REVISED DRAINAGE AND
GRADING PLAN
FOR
GUADALUPE PLAZA
EXPANSION AT 4TH STREET
AND GUADALUPE ROAD

Re: Cross-Lot Drainage Assurances for Guadalupe Expansion (E14/D3A)

Re: Drainage/Grading Plan for Guadalupe Plaza Expansion (E14/D3A)

RE: DRAINAGE PLAN FOR GUADALUPE PLAZA EXPANSION (E14/D3A)
RECEIVED OCTOBER 2, 1987

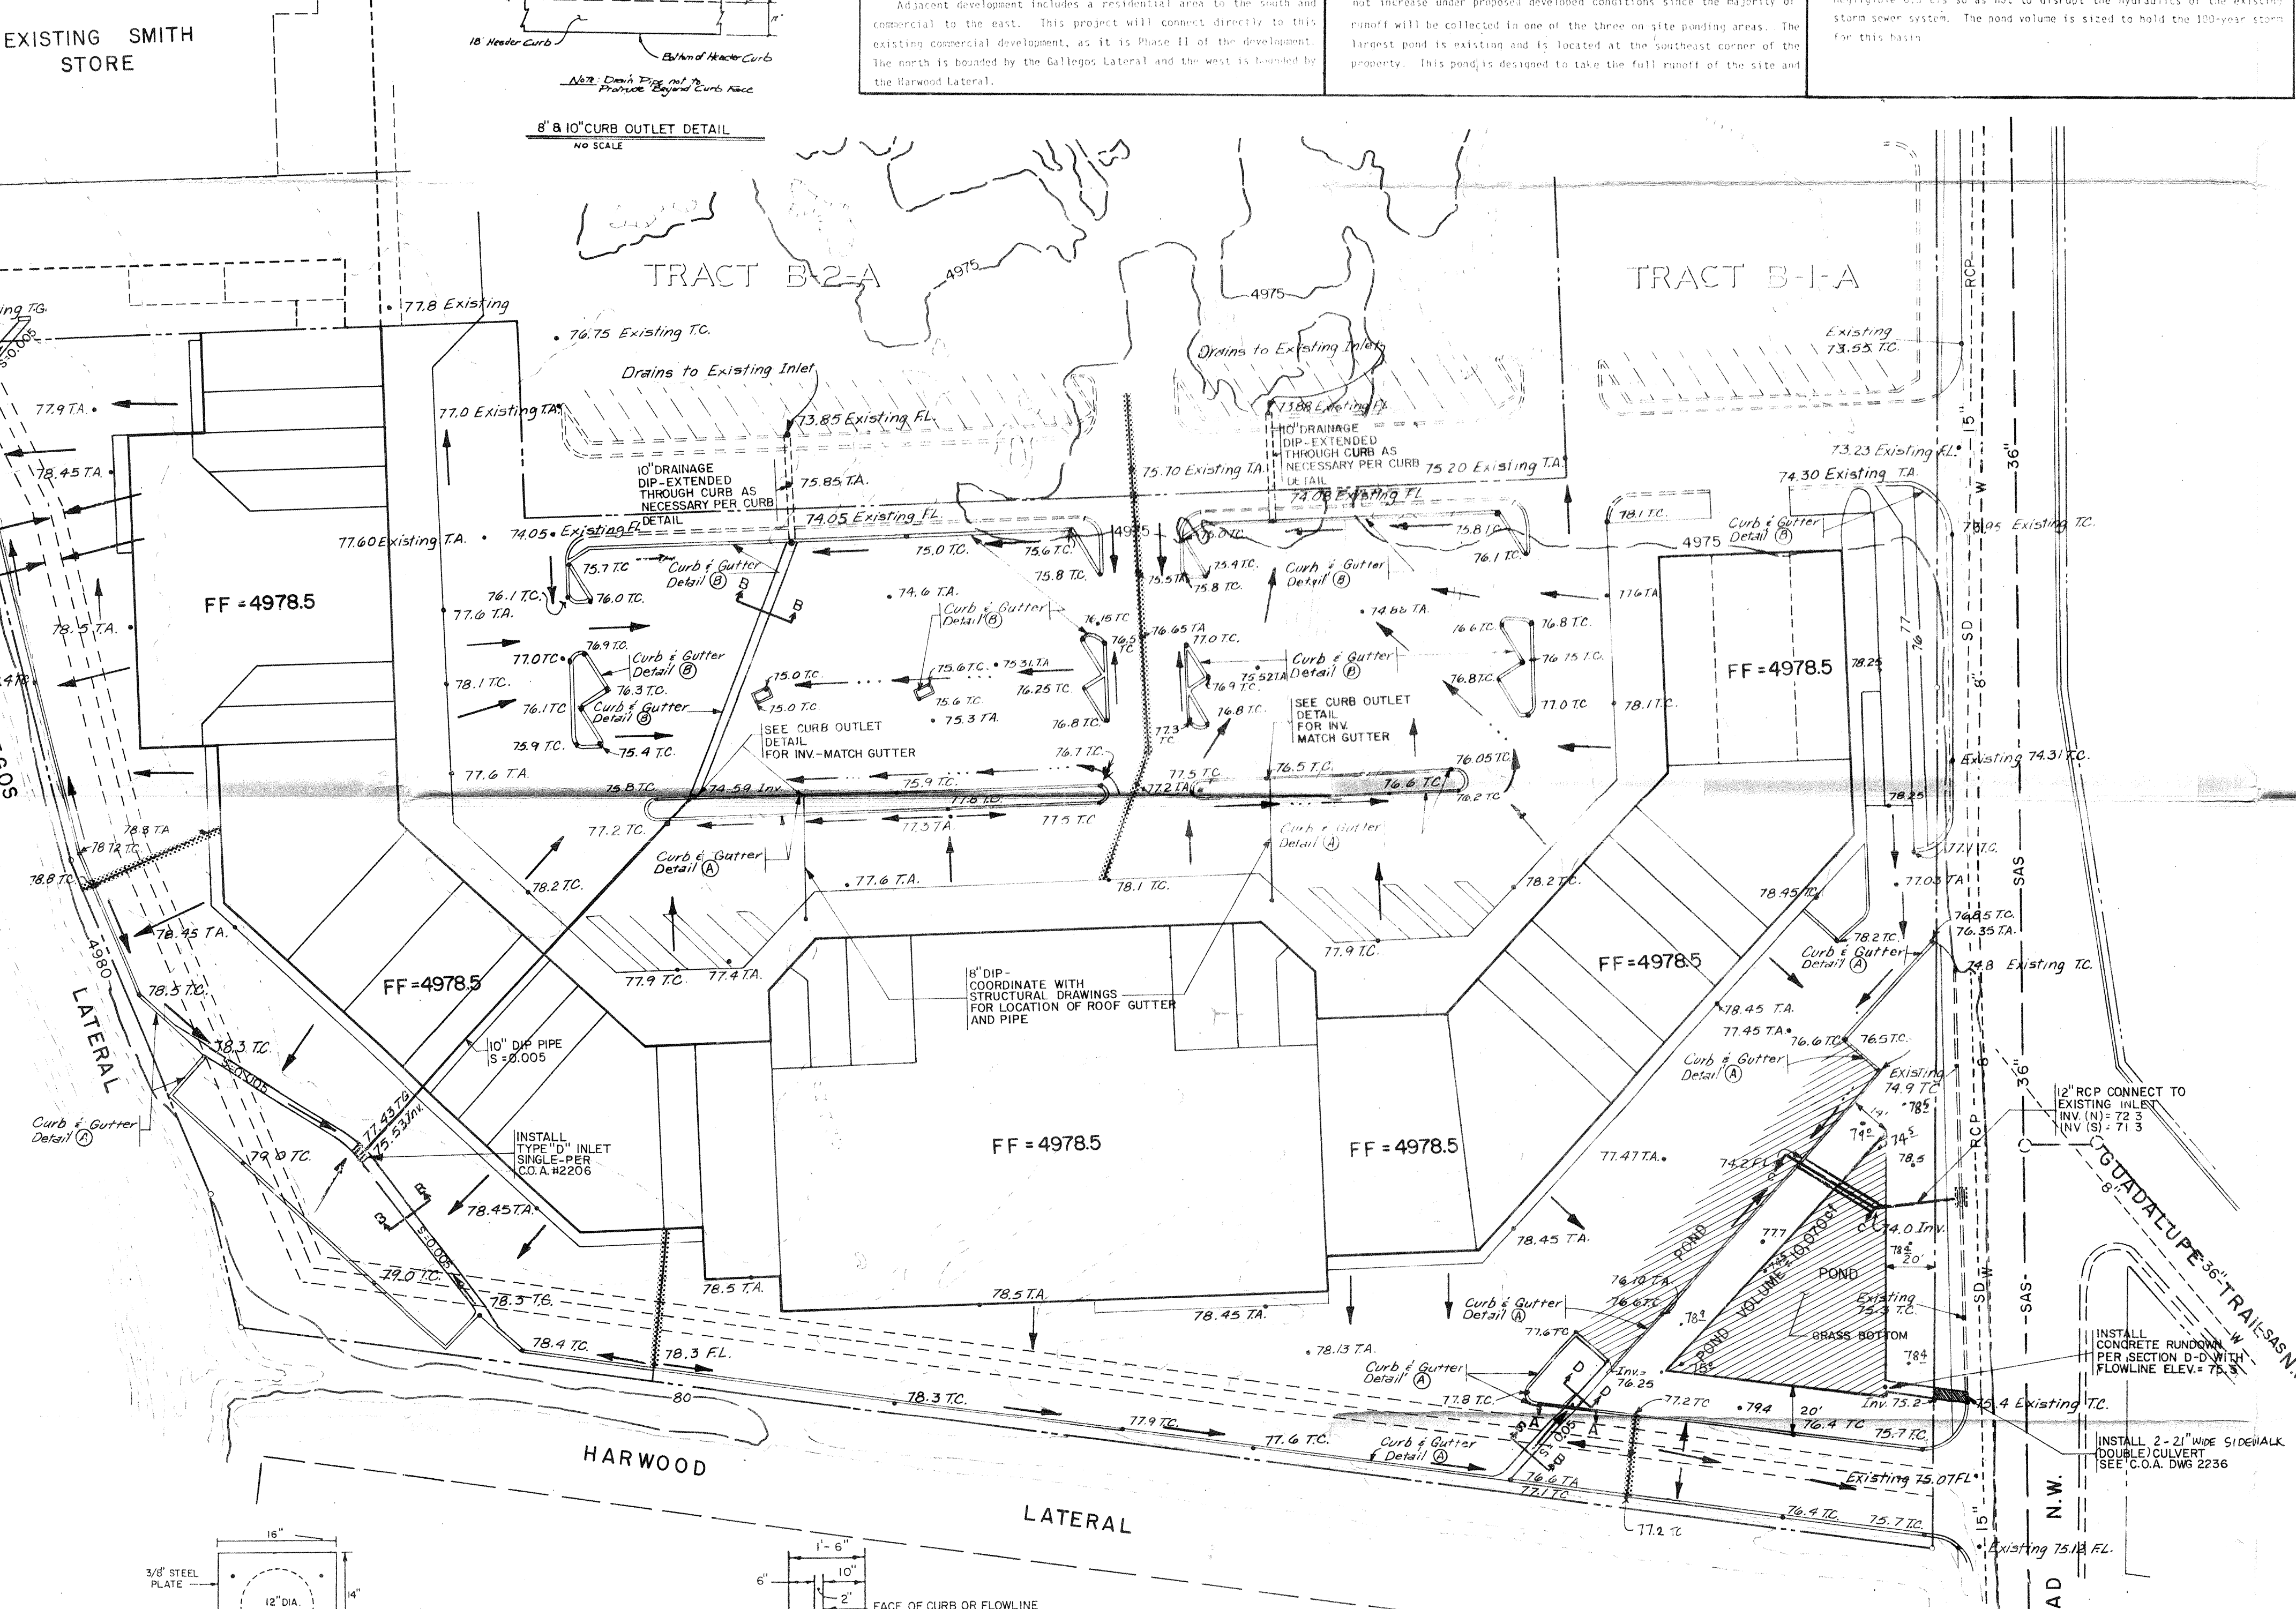
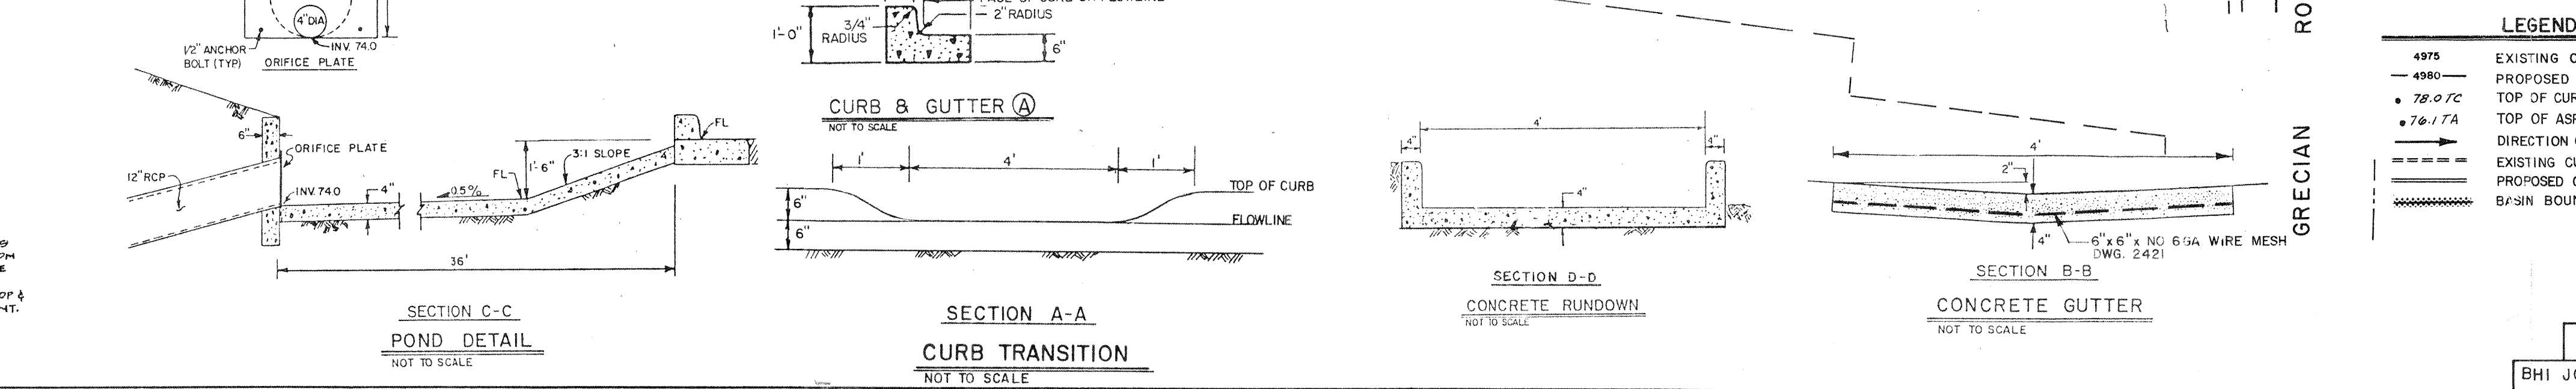
1. Confirmation of existing pond volume to which proposed Basins F, E, B and A will be routed to (does volume capacity exist, taking into consideration the existing Phase I portion?)
2. Retention ponds are no longer acceptable, therefore, Basin C must be drained within a 24 hour period.
3. Location of Emergency Spillway for Basin D.
4. Please provide a copy of document allowing cross-lot-line drainage.

1. For confirmation of the existing pond volume, please see the enclosed as-built plan of the Guadalupe Plaza Phase I drainage, which includes the pond volume of 52,457 c.f. In addition, please note that the 2 existing parking areas are designed to hold 24,300 c.f. each. Therefore, the total 100-year storm volume, designed and built during Phase I, is 101,057.00 c.f. We have calculated the required 100-year pond volume to be approximately 89,000 c.f., taking the ultimate buildout of the site into account (see enclosed calculation sheets).

Please note that the drainage/grading plan has been revised to show the majority of roof area draining to the west. This change, however, has been incorporated into the design calculations.

2. Since retention ponds are not acceptable, we have sloped Basin C so that it will drain directly into the street. This seemed the most reasonable solution due to the negligible amount of runoff this area will generate.
3. We have added an emergency spillway for the detention pond of Basin D, which is located at the southwest edge of the property.
4. Per our telephone conversation of October 15, 1987, I have sent a letter to the property owners of Tracts B-1-A and B-2-A, Guadalupe Plaza, to confirm their concurrence with the cross-lot drainage. We would ask that the review process continue with the understanding that final approval is dependent upon the City's receipt of this letter in the near future.

TITLE: GUADALUPE PLAZA EXPANSION (PHASE II)

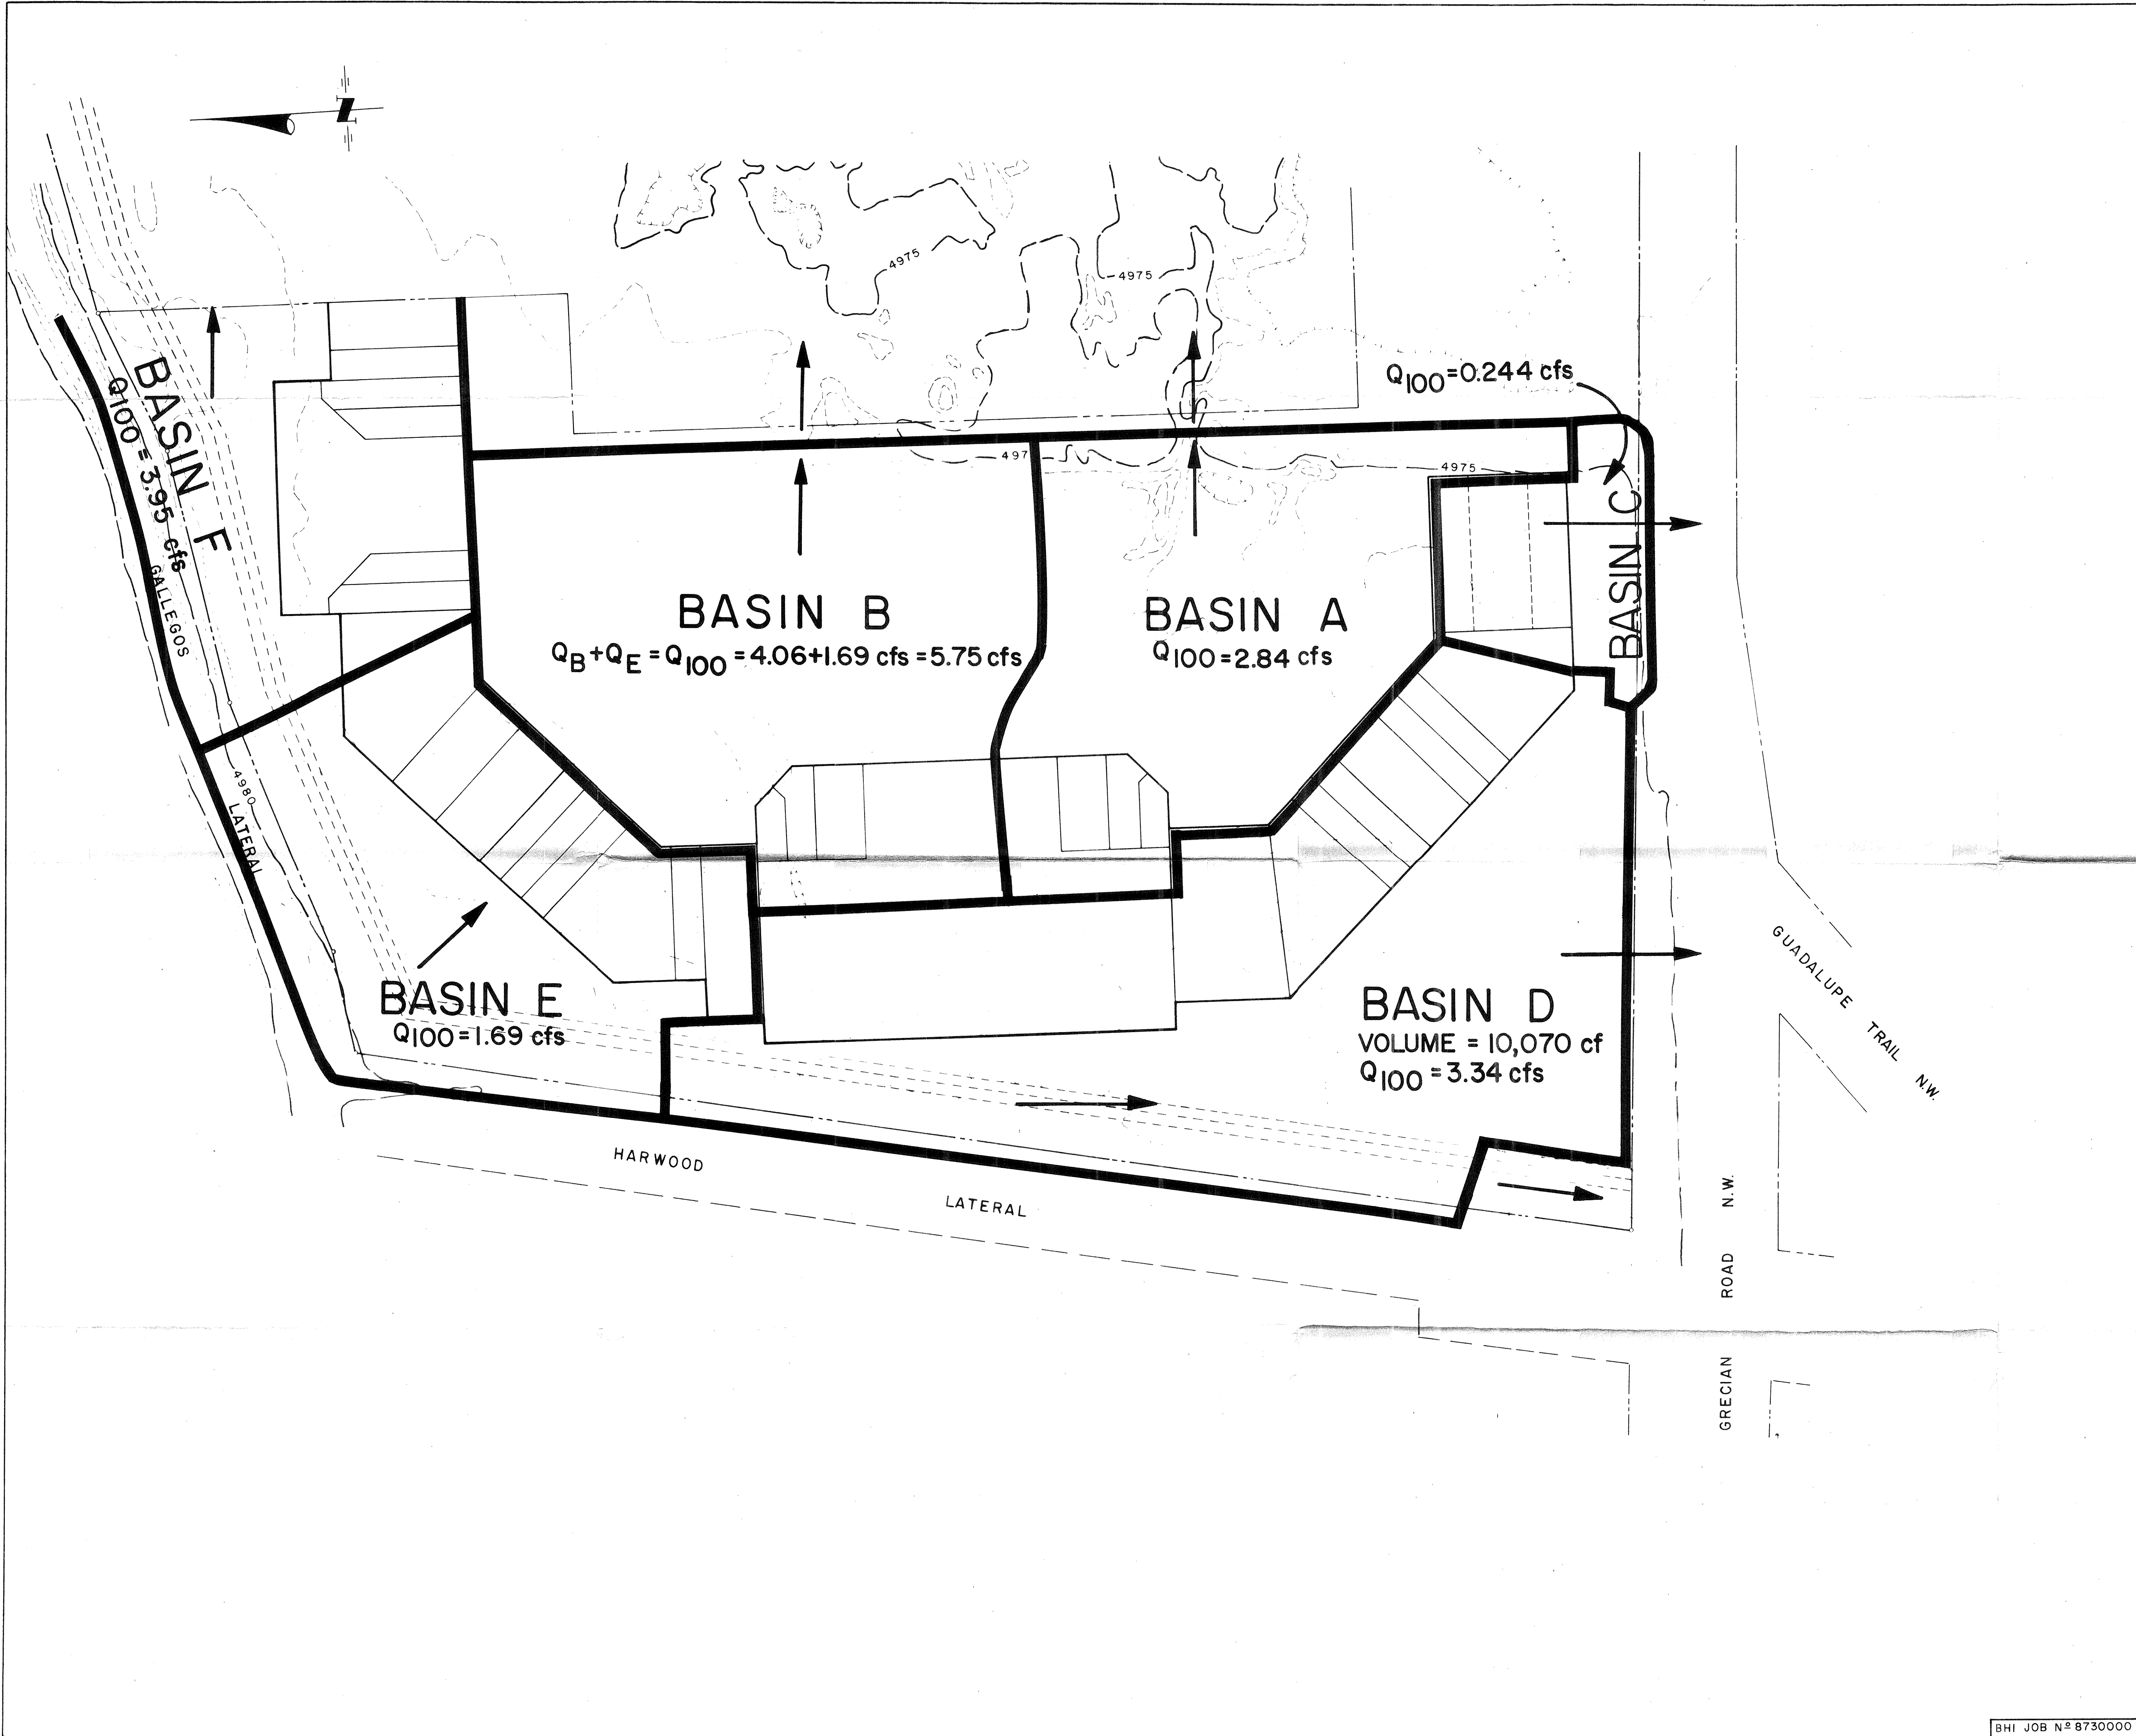
1. Finish floor elevations must be shown to full mean-sea-level designation.
2. On your plan drawing, the connection from the pond to the existing catch basin is shown as 36" PVC, your pond detail shows 12" RCP, please explain.

1. The finish floor elevations are now shown to full mean sea level designation.
2. The connection from the pond to the existing catch basin, as well as the pond detail, now shows a 12" RCP.
